Westinghouse  
Electric Corporation

ET-NRC-93-3905  
NSRA-APSL-93-0213  
Docket No.: STN-52-003

SUBJECT: WESTINGHOUSE RESPONSES TO NRC REQUESTS FOR ADDITIONAL  
INFORMATION ON THE AP600

ET-NRC-93-3905  
ATTACHMENT A  
AP600 RAI RESPONSES  
SUBMITTED JUNE 17 1993

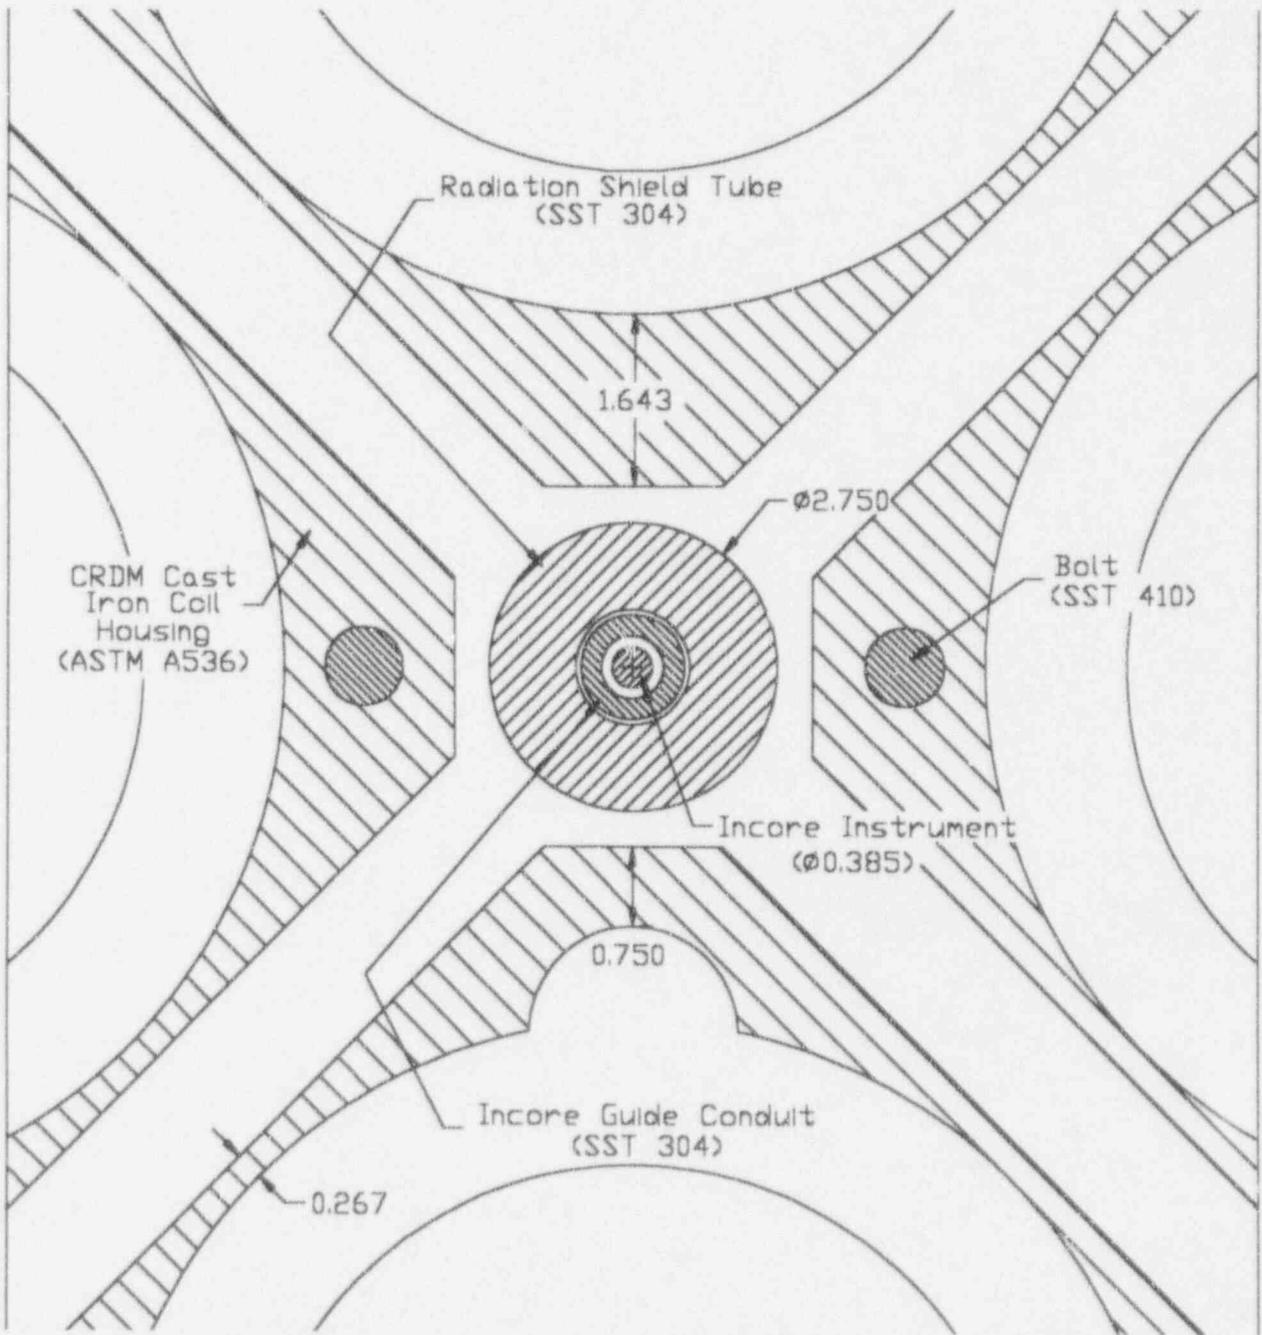
WCAP-12648, "AP600 Incore Instrumentation System Electromagnetic Interference Test Report," describes the test program that was conducted to investigate EMI concerns in the proposed AP600 Incore Instrumentation System (IIS). Provide clarification on the test configuration, test results, and Westinghouse's conclusions to respond to the following concerns:

- a. According to the Electric Power Research Instituted (EPRI) study, about 80 percent of EMI problems are due to the conducted EMI generated within the facility. Only 20 percent comes from radiated interference. Westinghouse's test configuration is only modeled for radiated interference. Provide justification for not considering the EMI effect from conducted EMI.

- b. The test configuration should be close to the actual plant configuration. If configurations are different, then an analysis should be performed to address the factors affecting the test results. Describe the differences between the test configuration and the AP600 plant configuration, including the circuit grounding arrangement. For example, the FID assembly consists of a thimble tube approximately 50 feet, but the test configuration used only 6 feet of Mineral Insulated (MI) cable. Is this a fair representation?

- i. What is the reason for displaying test results in a time domain instead of a frequency domain? Provide the test results in a frequency domain.
- j. The actual design of the FID circuitry has low-pass filters to eliminate high frequency interference. What is corner frequency of this filter? How effective is it against the EMI from the CRDM coil?

Since the test reported in Reference 1 was performed, a 304 stainless steel radiation shield, shown in the attached figure, was added. This shield will provide additional EMI/RFI shielding for the fixed incore detector (FID).

- e. The primary material used for the CRDM housing is ASTM A536 ductile cast iron. There are also 410 stainless steel bolts, a 304 stainless steel guide conduit, and a 304 stainless steel radiation shield tube, as shown in the attached figure. These materials were not chosen for specific electrical or magnetic properties. Data to estimate the conductivity and permeability is available in the Standard Handbook for Electrical Engineers. The attached figure, "CRDM and FID Cross Section" provides thickness data.

- f. The range of frequencies to which the FID is vulnerable will be addressed in the equipment qualification test. The FID signals will be heavily filtered since the detector response is inherently slow.

- i. This was a limited test to determine levels of EMI coupling. No data was taken in the frequency domain.

- 
- j. The corner frequency of the FID circuitry will be selected to be consistent with the response characteristics of the detector to reduce interference from EMI to an acceptable level.
